Application No. A/NE-TKL/837

Section 16 Planning Application for Temporary Open Storage of Recycling Materials and Metalware with Ancillary Facilities and Associated Filling of Land for a Period of 3 Years at Lots 86 (Part), 87 and 89 in D.D. 83 and Adjoining Government Land, Kwan Tei North, Fanling, New Territories

Submission of Further Information 2

Responses to Departmental Comments

Legend

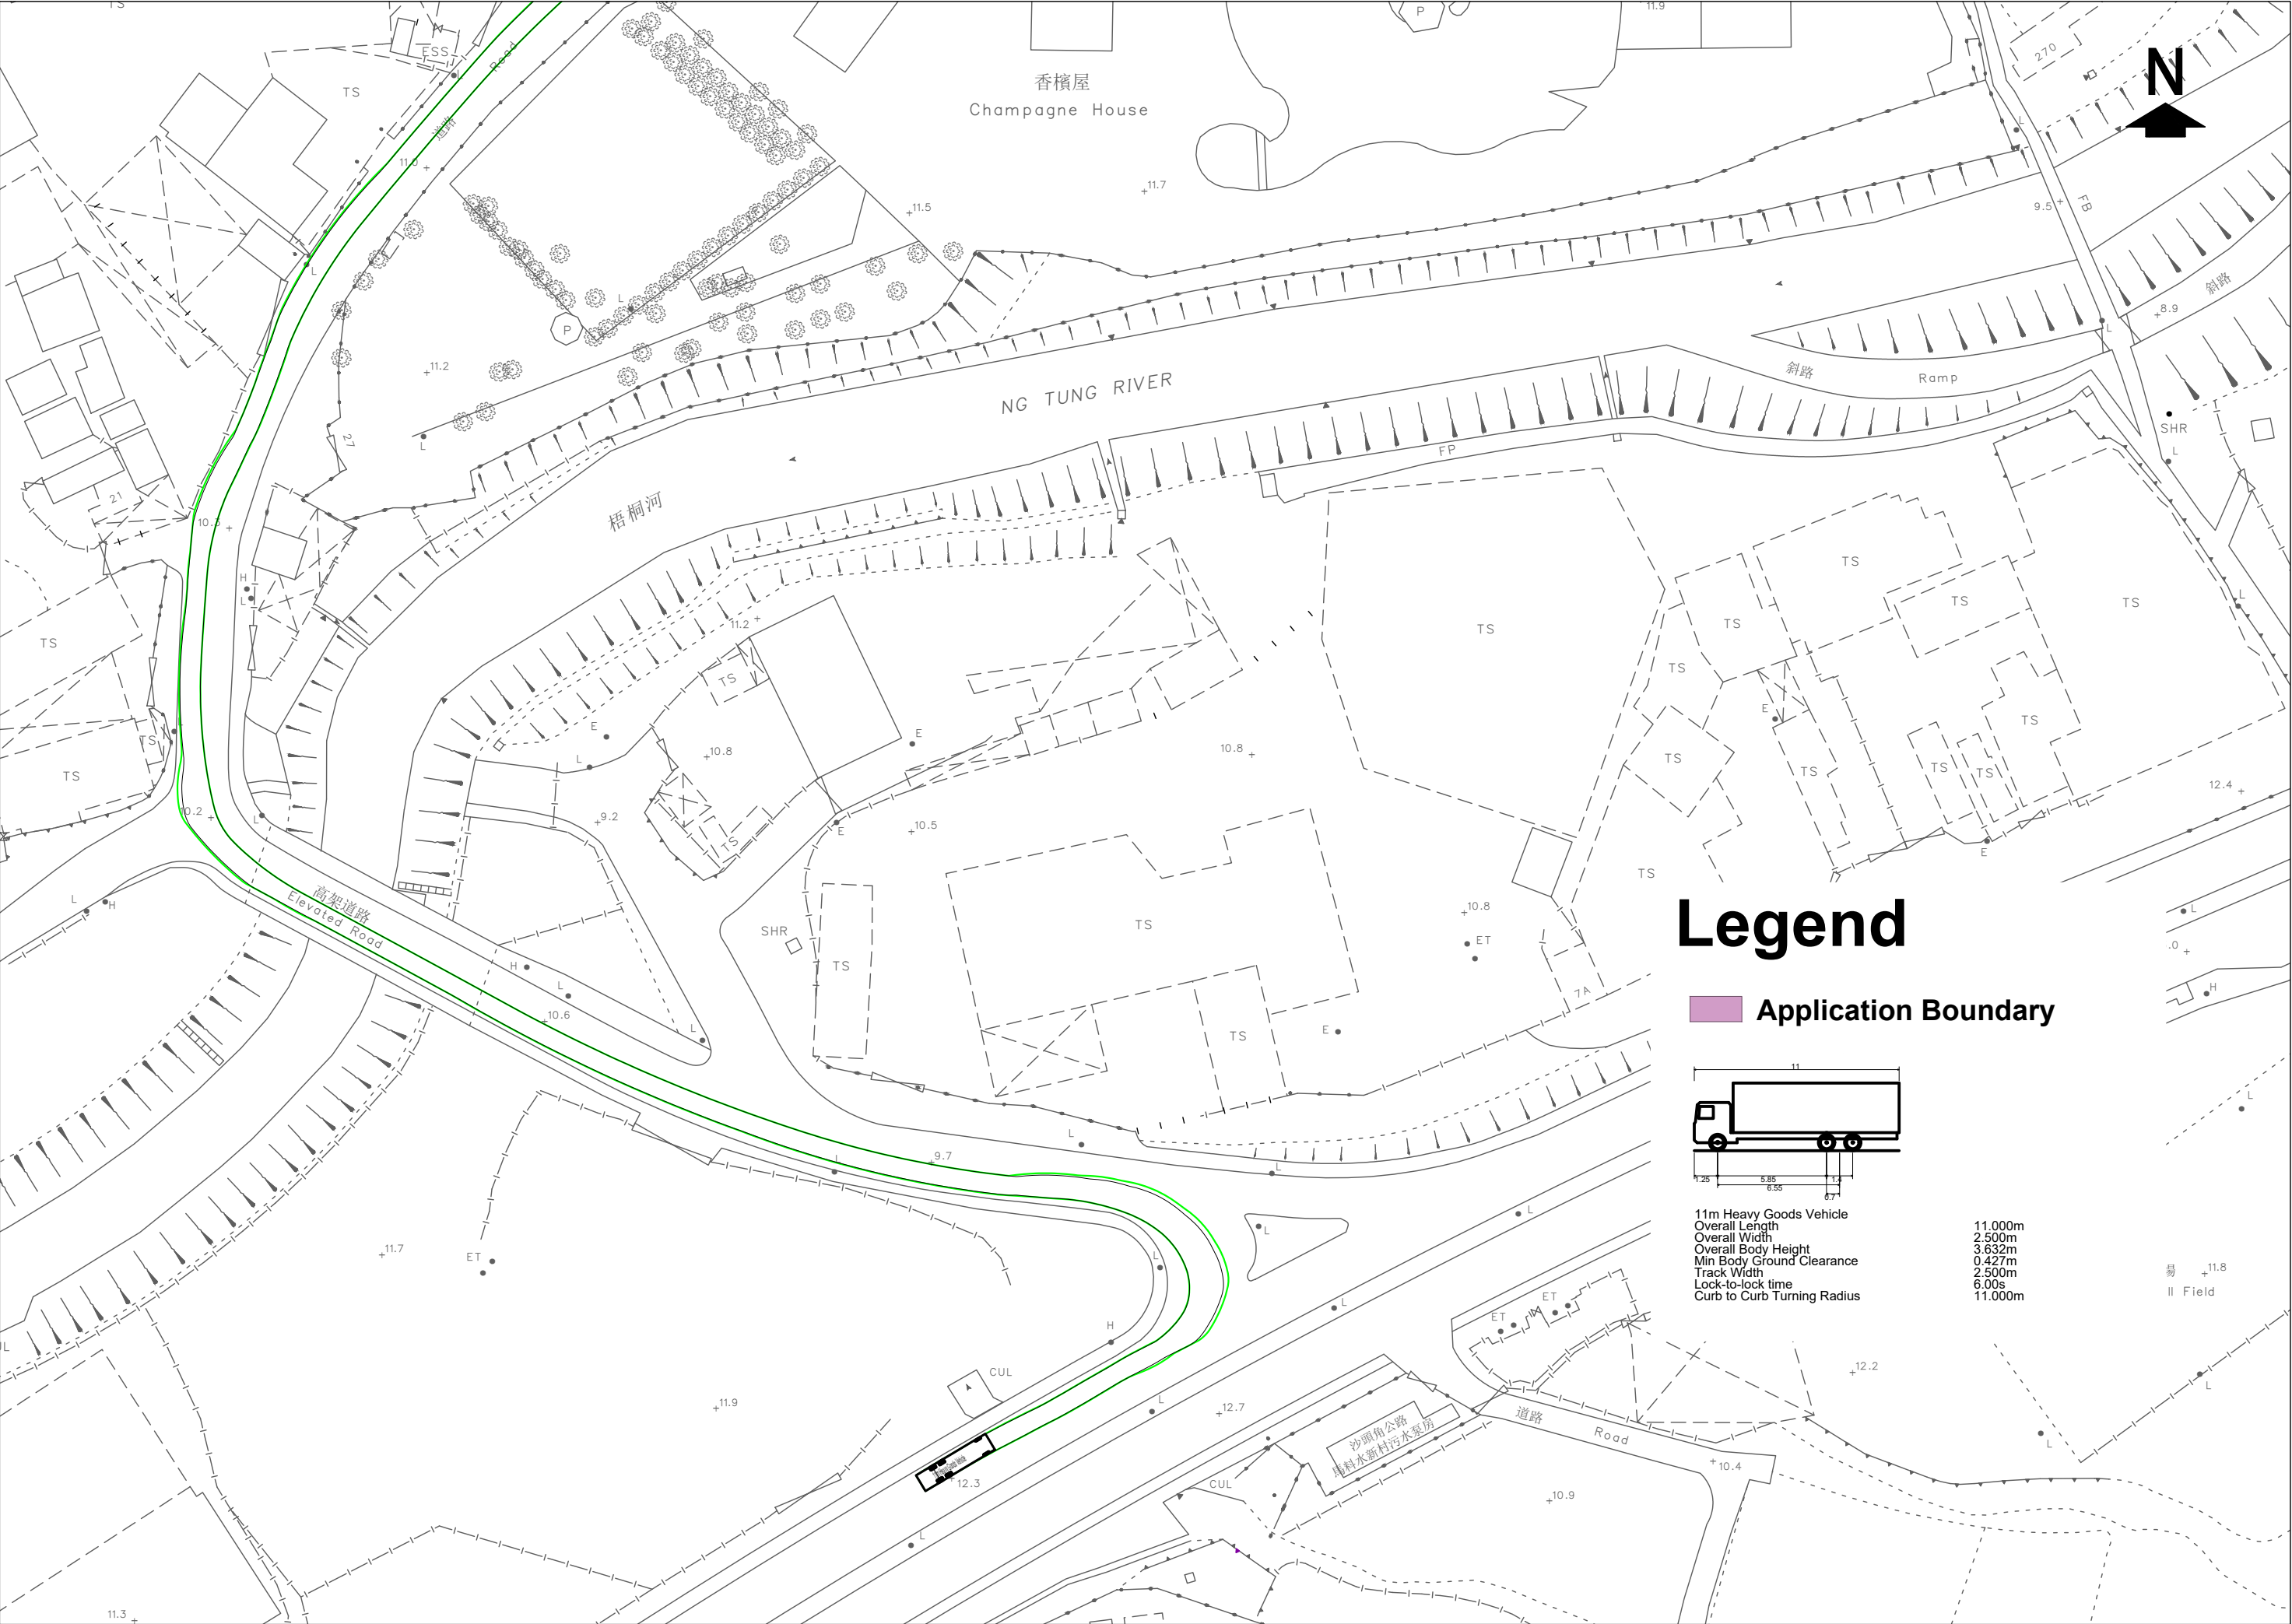
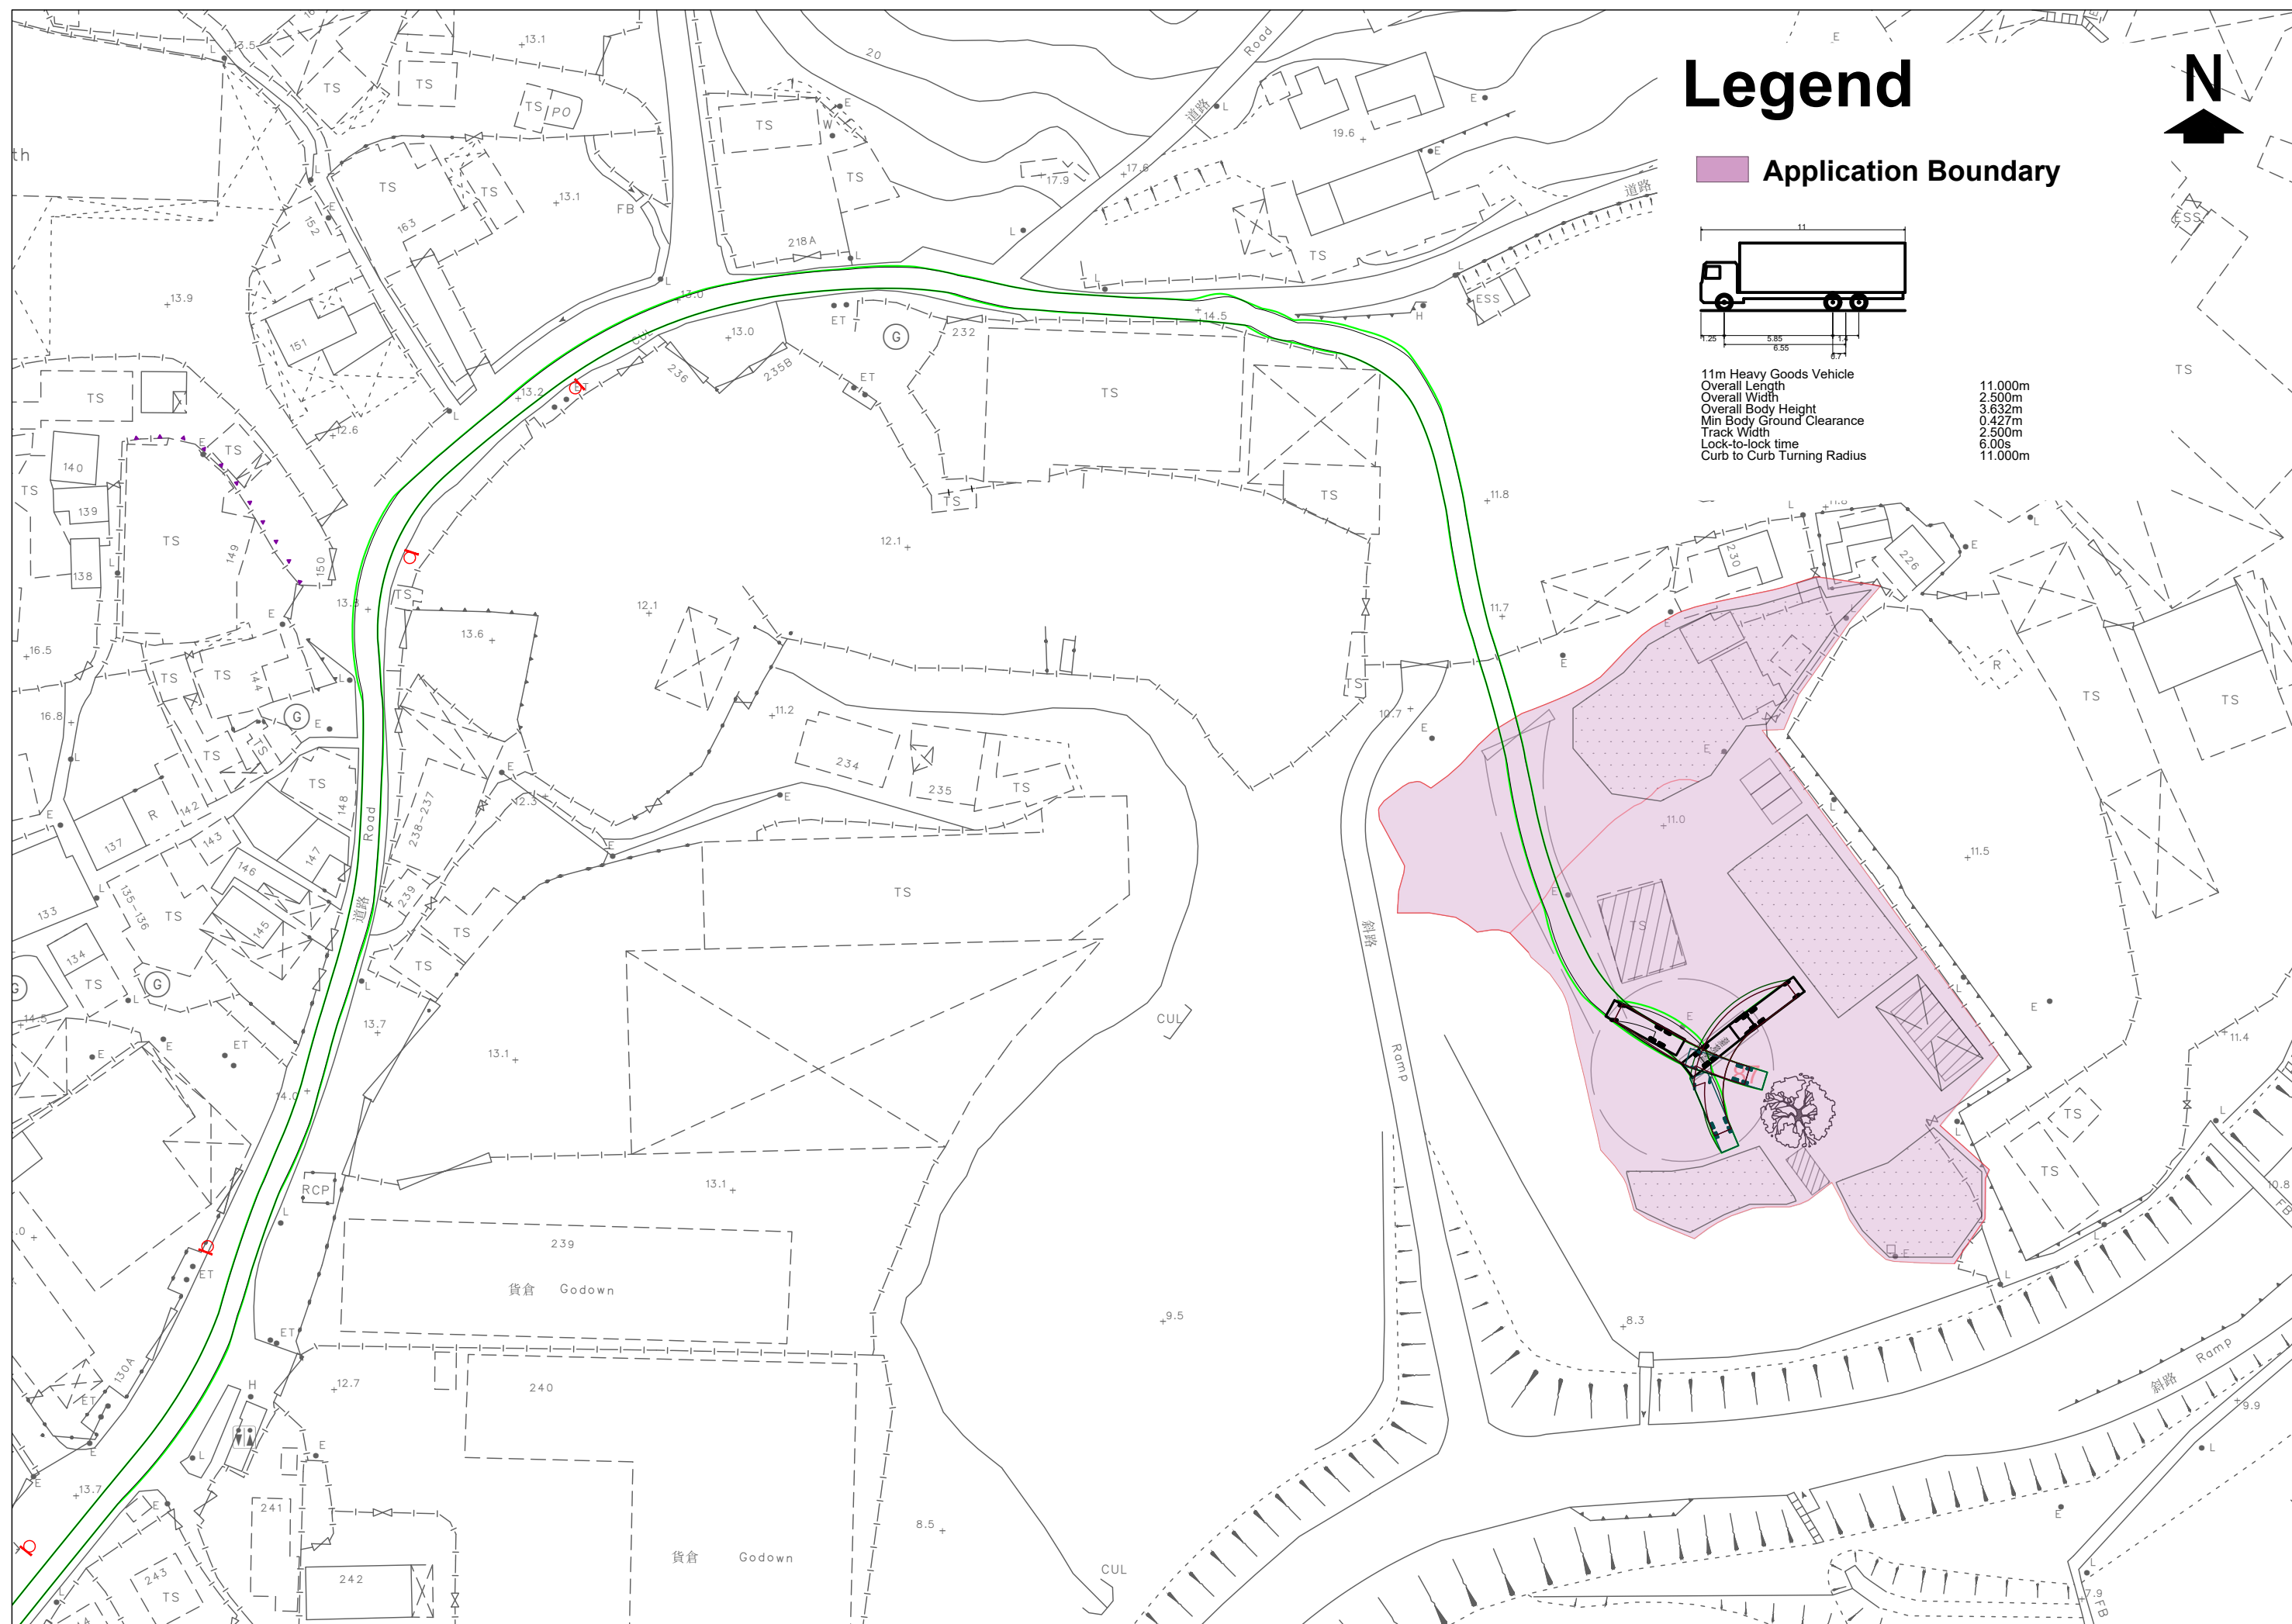
Item	Departmental Comments	Applicant's Responses
1. Comments from Transport Department received on 18.5.2026		
	- the dimension of good vehicles used for swept path analysis should follow the table 5.4.4.1 in Volume 7 of TPDM; and - the applicant should propose measures, such as installation of traffic warning signs and provision of passing bays, to ensure that the movement of site vehicles will not clash with the vehicles riding in opposite direction along the access road linking Sha Tau Kok Road - Lung Yuek Tau to the application site.	The revised swept path analysis is attached at Annex 1 of this FI submission. Please refer to Annex 2 for the proposed traffic warning signs along the access road, which are located on Government land. Upon approval of the application, the Applicant will apply to the relevant departments for permission for the installation of the signage.
